EcoVapor’s comments regarding MAP report on Separators/Heaters/Storage Vessels and Permitting Incentives

EcoVapor's comments regarding MAP report on Separators/Heaters/Storage Vessels

Re: Comments Regarding MAP Draft Report on Separators / Heaters / Storage Vessels and Permitting

Figure 1 - Modified Production Facility Process Diagram

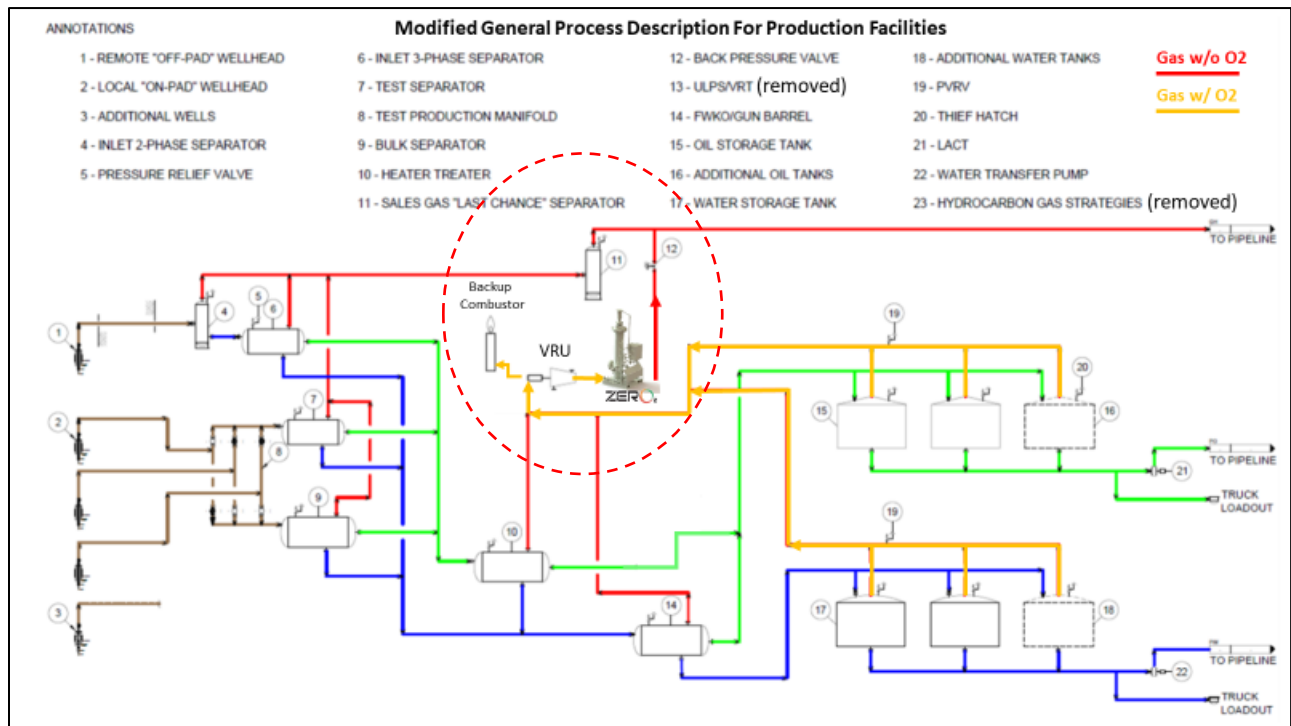
Below, in Figure 1, we present a modified version of the General Process Description for Production Facilities to help illustrate how an EVR system functions. The modifications are as follows:

- 1) The ULPS/VRT is removed, and the oil flows directly to the oil tanks.
- 2) Flowlines off the oil tanks, water tanks, heater treater and FWKO have been joined together and re-colored to indicate that the gas stream likely contains oxygen.
- 3) These combined streams are routed to a VRU that is also connected to a backup flare or combustor system to be used during maintenance or unplanned downtime.
- 4) The VRU is connected to a gas conditioning unit (EcoVapor's ZerO2) that removes the free oxygen down to levels acceptable to gas gatherers, gas processors and mainline transporters, alike.
- 5) A legend has been added to the ANNOTATIONS section to show and differentiate gas with oxygen (orange) and oxygen-free gas (red).

The key difference in Figure 1 is the removal of the ULPS/VRT and the addition of the oxygen-removal unit. This change greatly increases the ability of a production facility to capture all the tank flash gas instead of just a portion of it. Both modeling and empirical data have shown that vapor recovery towers (VRTs) often capture between 60% to 75% of the entrained gas, leaving the rest to evolve from the oil once it enters the oil storage tanks. That gas pressures up the tanks, potentially resulting in leaks and venting, or, in the best case, pushing the gas to combustors or flares.

Figure 3 - Tank Truck Emissions Capture

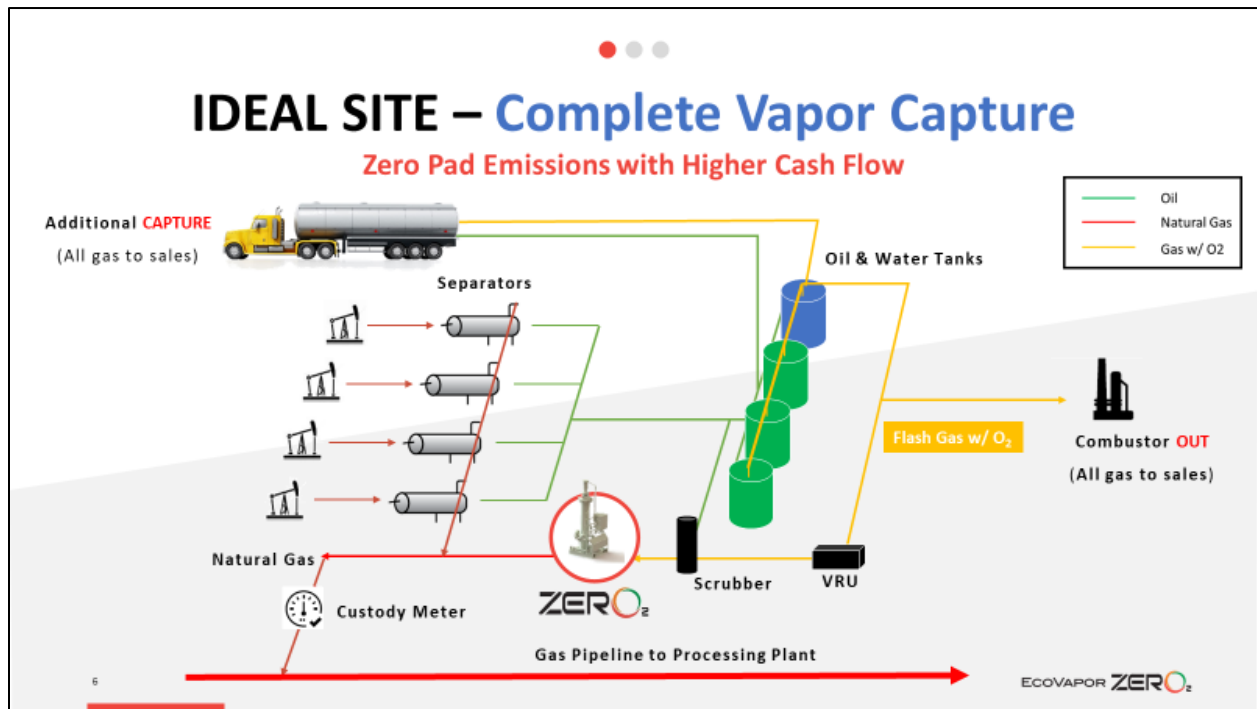
Controlling emissions during truck loading is another benefit of using an enhanced vapor recovery system. Tank truck vapors contain high levels of oxygen as well as hydrocarbons. Without oxygen removal systems, truck vapors are either simply vented to the atmosphere or are directed to back to the tanks and then to a flare or combustor, releasing VOCs and/or NOx in the process.

Alternatively, an EVR system allows this gas to be routed back to the tanks and then to where the oxygen is removed. The remaining stream is captured and sold, minimizing emissions of both VOCs and NOx (see Figure 3 below).
